February 2023

**URGENT FIELD SAFETY NOTICE
MEDICAL DEVICE CORRECTION**

Datascope Cardiosave Hybrid and Rescue Intra-Aortic Balloon Pumps (IABP)

Figure 2: As pictured in Cardiosave Hybrid and/or Rescue Operating Instructions

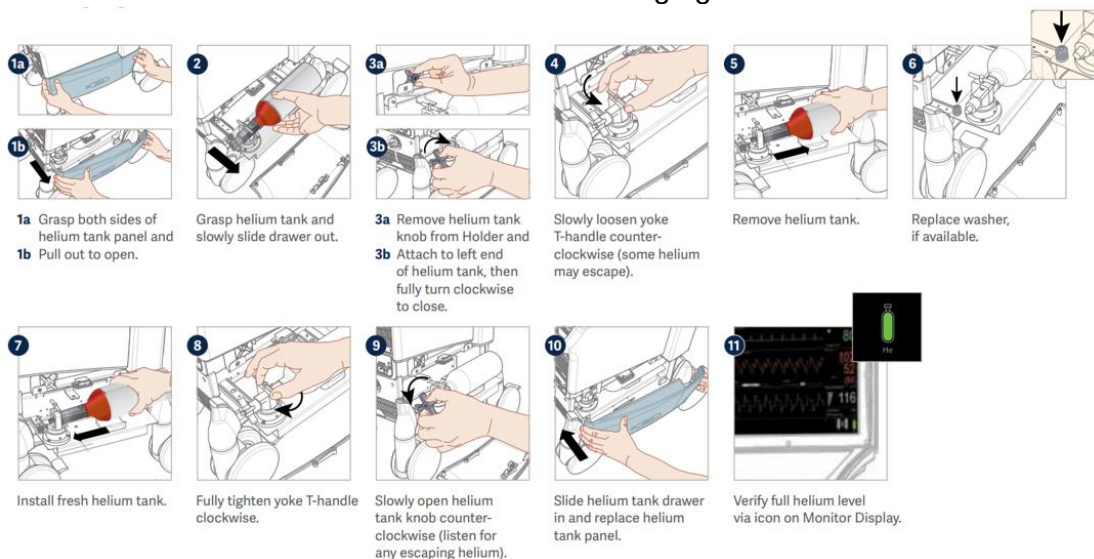
There have been reported failures of the high pressure helium regulator which may cause a helium leak in the Cardiosave Hospital Cart. The high pressure helium regulator is located in the Cardiosave Hospital Cart and regulates the helium pressure of the external helium supply. In instance of helium regulator failure, a Pump Console's internal reservoir of helium will not be replenished when docked into an impacted Hospital Cart. This may result in an insufficient amount of helium within the internal reservoir. Please refer to images below for reference.

1. During Installation and Replacement of Helium Tank per the Cardiosave Operating Instructions, please ensure care is taken not to damage the helium tank or the helium tank yoke while inserting and/or removing the helium tank.
2. Please follow the instructions for use when changing the helium tank.

3. If user observes any visual damage on High Pressure Regulator, please contact your Datascope/Getinge service representative.

Datascope/Getinge is currently investigating this issue to determine root cause and will notify customers if additional action is to be taken to correct the issue.

Figure 3: Drawings as pictured in **Cardiosave Hybrid and/or Rescue Operating Instructions**, along with a final picture of the O-ring as it appears on the unit.

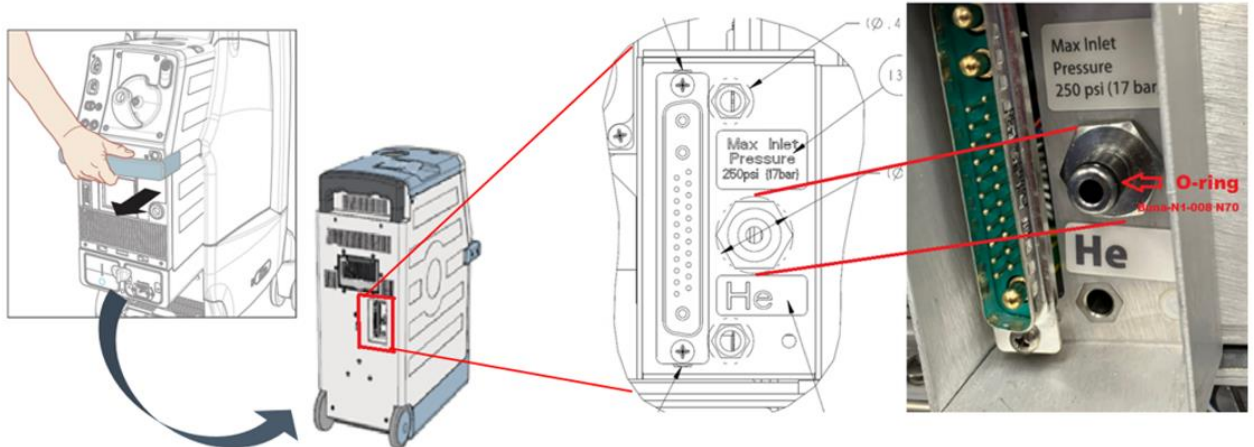
There have been reports of damaged, worn, or torn O-rings on the Cardiosave Pump Console quick disconnect fitting resulting in helium tank leaks. The quick disconnect fitting is the point of connection that permits the refilling of the Pump Console's internal helium reservoir when the Pump Console is docked in the Hospital Cart. Please refer to images below for reference.

1. If user observes any visual damage to the O-ring installed as part of the quick disconnect fitting, please contact your Datascope/Getinge service representative. If possible, remove the IABP from patient use until appropriate repairs can be made.

Datascope/Getinge is currently updating the annual Preventive Maintenance instruction to include replacement of the quick disconnect fitting O-ring.
